PD sensors, similar to those discussed in Paper 10742, were evaluated in a large research project funded by the Canadian Electrical Association (CEA, and now known as CEATI) in the 1980s. Three different designs were evaluated for installation on the grounded enclosure of isolated phase bus (IPB):

Figure 1: “directional time of arrival” method to separate signals from the three regions

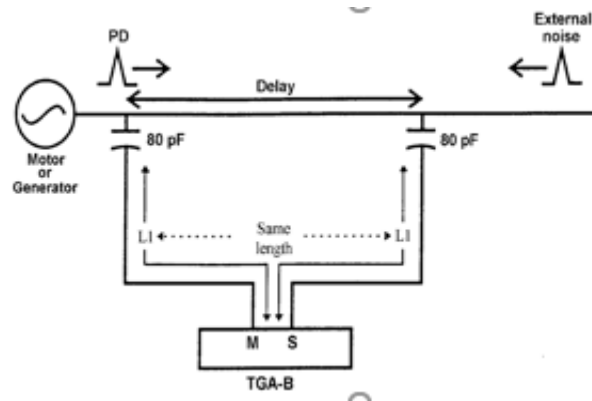
All three types had a capacitance from between 2 pF to 10 pF. 5:1 RF transformers (by RF Minicircuits) were also sometimes used to lower the cutoff frequency of the coupler. Two such capacitors were installed per phase, to enable the time of arrival (ToA) method to separate stator PD from signals originating between the couplers, and also from signals from the power system (from beyond the second coupler (Figure 1).

Figure 2: 80 pF couplers connected to the TG terminals. Note that any arcing/sparking from the flexible links will be classed as stator PD by the time of arrival method.

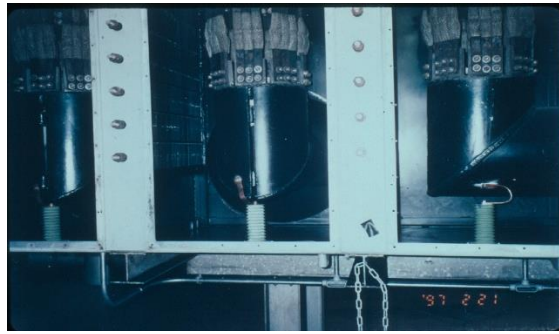
- The signal magnitudes were much smaller than those obtained from 80 pF capacitors connected to the IPB (Figure 2)
- In practice the capacitance, and thus the measurement frequency could not be controlled within a narrow range, which made comparisons of signal magnitudes between different machines difficult
- In practice, it was not possible to install such non-contact couplers as close as possible to the machine terminals. This increased the risk of noise from cracked or improperly installed post insulators from causing false positive indications.

As the authors state, the time of pulse arrival (ToA) method has proven its worth in separating power system noise from stator PD. However, there is a limitation. If any bolt on the flexible links to the generator bushing is arcing, even if it is relatively harmless, this leads to false positive indications. Also a cracked or poorly installed post insulator (again usually harmless) within 1 m of the coupler (assuming a detection bandwidth of 300 MHz) will cause a false indication. If lower detection frequencies are used, the zone where post insulators can cause false indications is longer. Since such issues occur on about 30% of older TGs/IPBs, this led to the development of SSCs (UHF antenna installed within stator slots). SSCs have a significantly lower risk of false indications on hydrogen-cooled TGs equipped with 80 pF IPB couplers [2].

Fixed capacitors (80 pF) galvanically connected to the HV bus overcame these limitations. Such 80 pF couplers have now been installed on >27,000 generators and motors (including 12,000 TGs). The apparent limitation of being connected to the HV bus has been overcome by:
